PROPOSED CHANGE NO. SC-01-002R1

Date: July 24, 2025
File: 9.1.7.4.2_SC-01_PC
Project No.: 2215C
Project: TA Blakelock HS Reno - Phase 3
Subcontract: SC-01 General

Description: Elevator 2 (drama area)

CONTEMPLATED CHANGE NOTICE No. S1

1. ALL FRAMES AND SHORING JACKS TO BE PLUMB AND LEVEL.
2. SHORING JACKS TO BE DESIGNED BY THE SUPPLIER FOR THE LOADS AND HEIGHTS SHOWN, INCLUDING BRACING.
3. MAX. EXTENSION OF SCREWJACKS WILL BE 400mm UNLESS NOTED.
4. SCAFFOLDING SHALL BE ERECTED IN ACCORDANCE TO C.S.A. CODE S269.1.

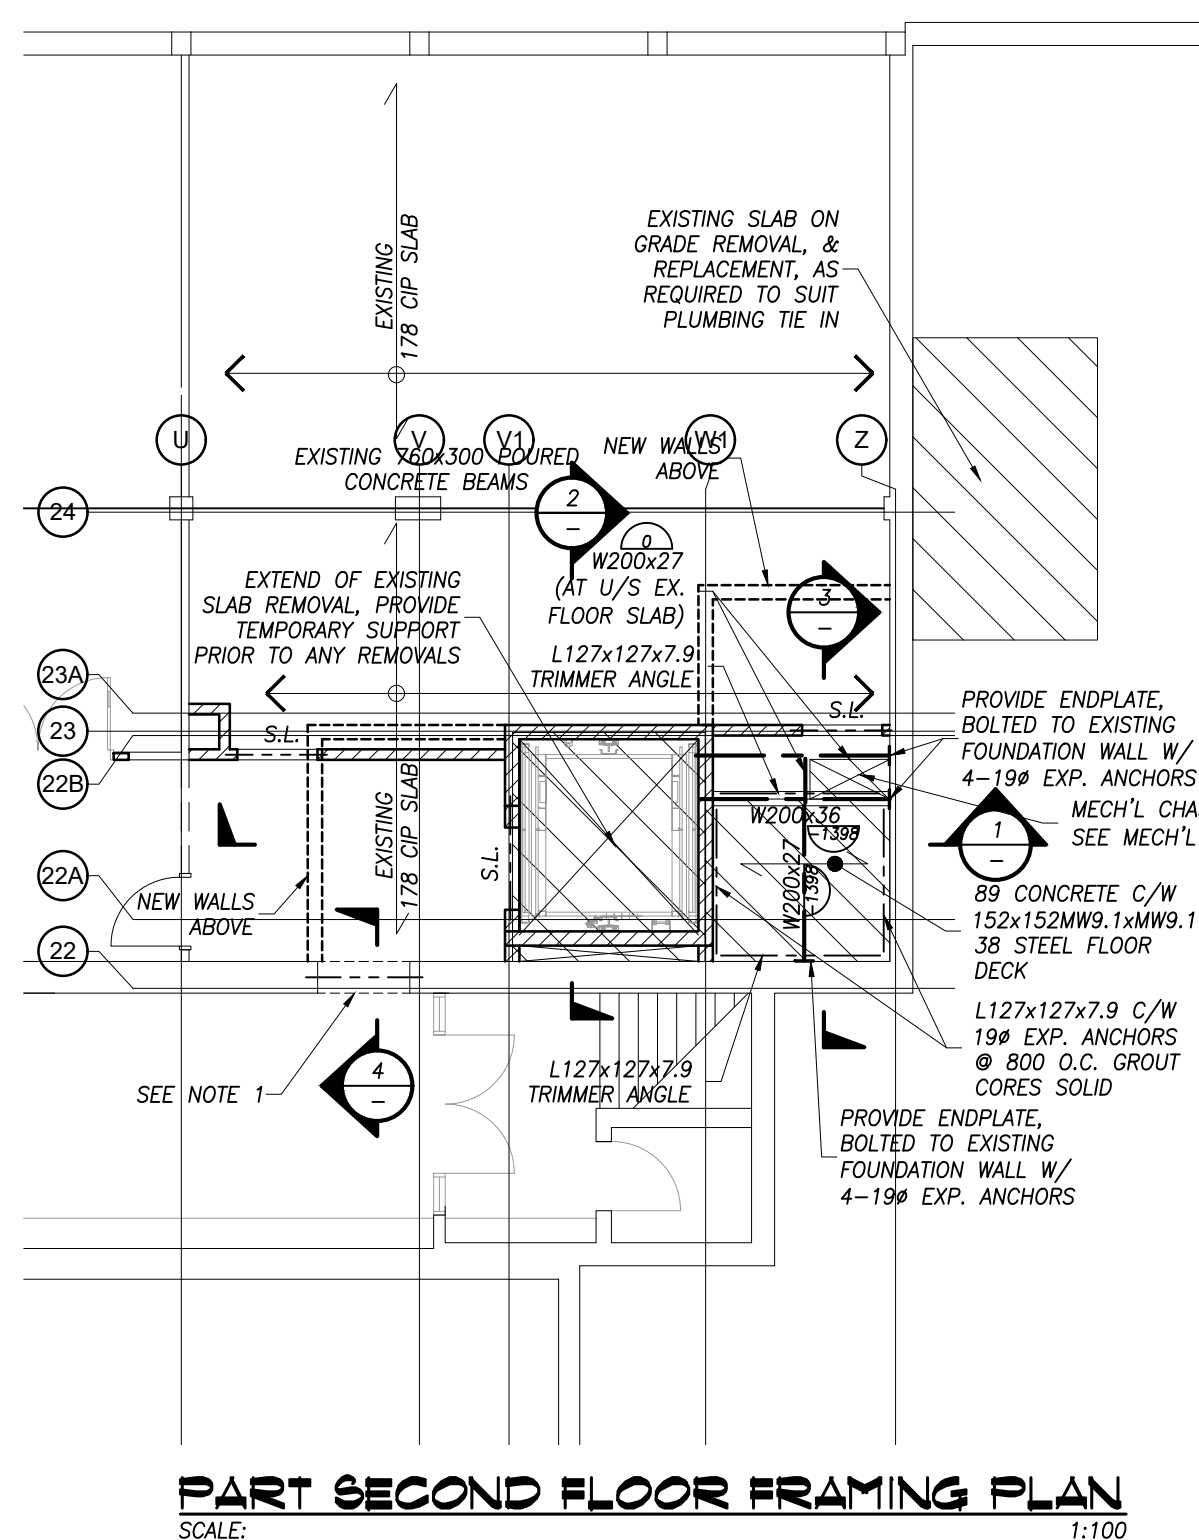
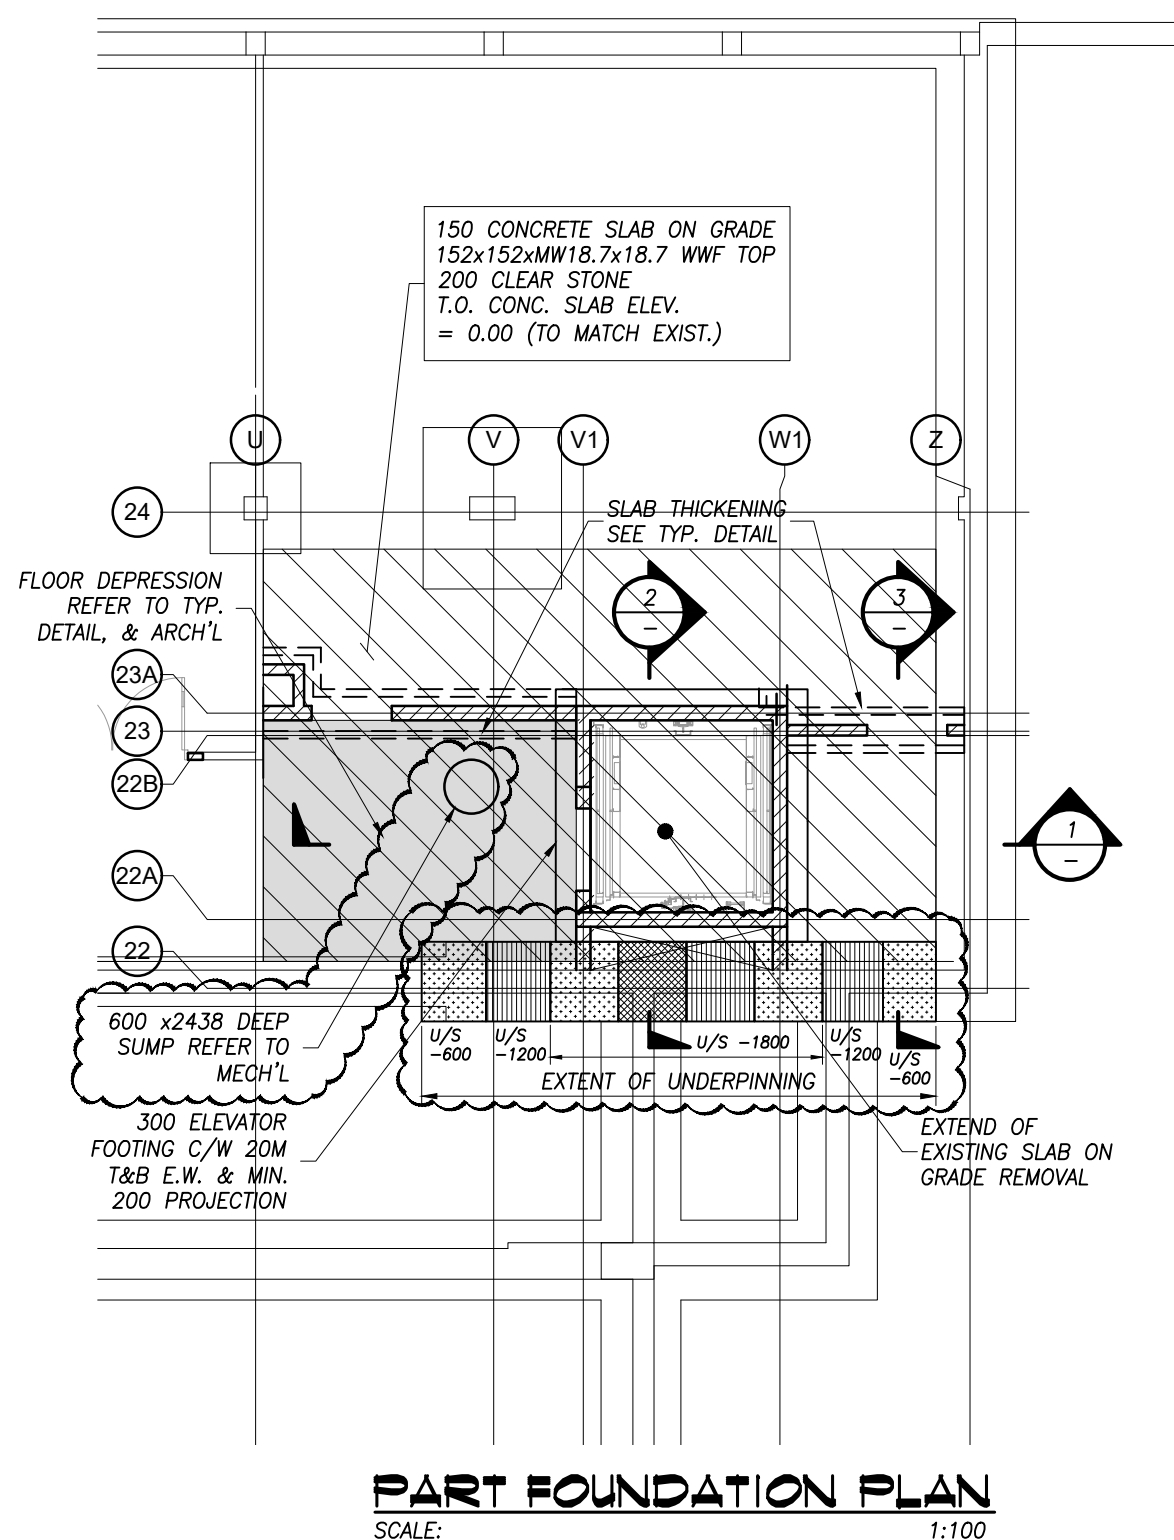
1. Underpinning extents and depths for Elevator 2 revised. Refer to updated drawing S300.
2. Foundation support for new column in Washroom Renovation revised. Refer to updated drawing S100.
